Port Kembla Development DA Modification Summary of Changes

Meeting with PKPC, AAT & GrainCorp Re: DA Modification

Meeting with PKCT Re: DA Modification

Change in Location of Biodiesel Refinery

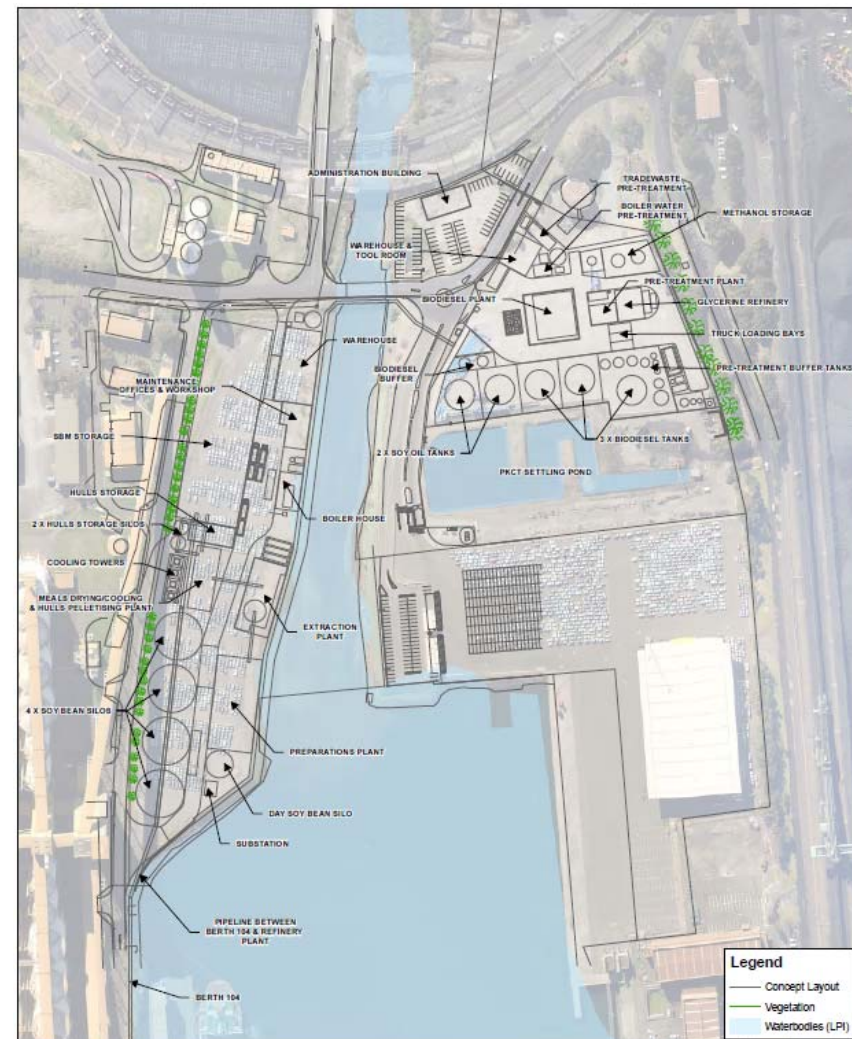
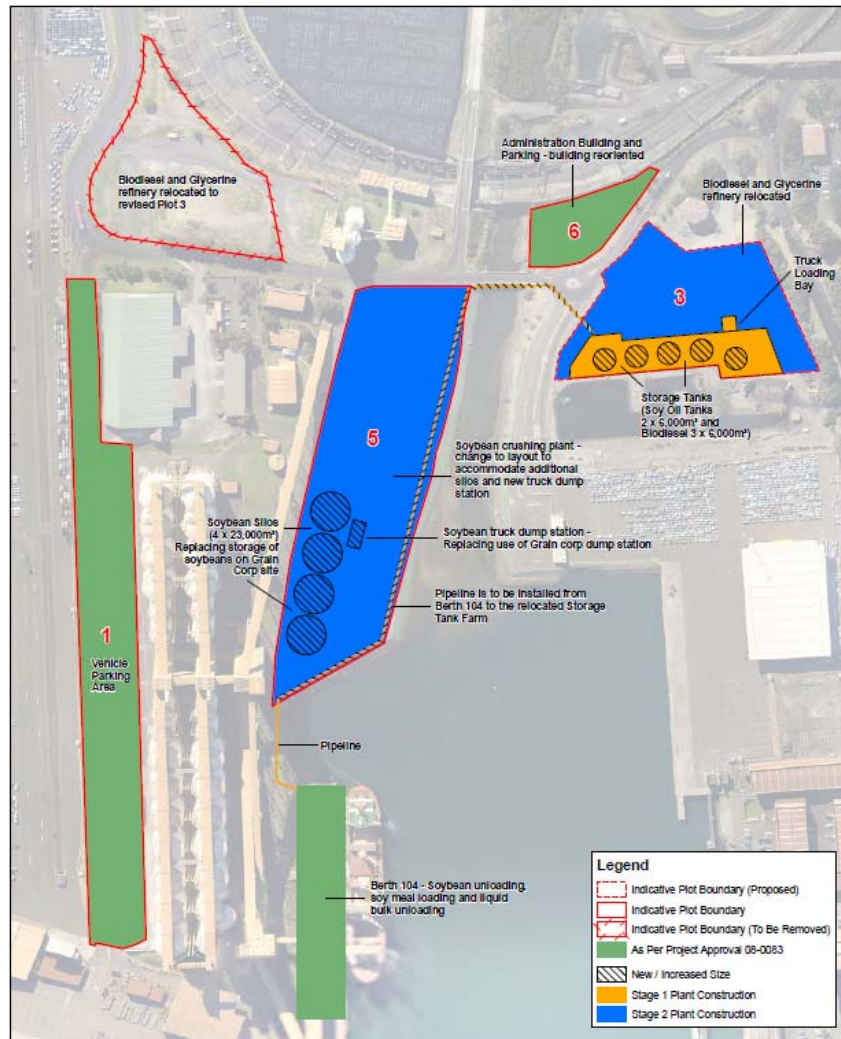
Change No.	Description	Original DA Consent (approval no. 08_0083)	Proposed Change
1	Location and size of Plot 3, Biodiesel plant site	PT lot 20, DP1046295, 1.55 Ha land area	PT lot 2, DP 1125445, 1.8 Ha land area, located approximately 250m east of original Plot 3
2	Additional Bulk Storage Capacity for Biodiesel and Soybean Oil on Plot 3	3 x 5,600m ³ Biodiesel storage tanks located on Plot 3. 1 x 10,800m ³ ML Soybean Oil storage tank located on Plot 5.	3 x 6,000m ³ ML Biodiesel storage tanks located on Plot 3. 2 x 6,000m ³ Soybean Oil storage tanks located on Plot 3.
3	Liquid Bulk Unloading Facility at Berth 104	Ship unloading facilities at Berth 104	Addition of liquid bulk unloading facilities at Berth 104
4	Soybean Storage Silos and Truck Dump Station	Use of GrainCorp's existing facilities; 7 x 10,000t silos, 2 x 5,000t silos and a truck dump station	Construction of 4 x 20,000t soybean silos, truck dump station and associated conveyors on Plot 5.
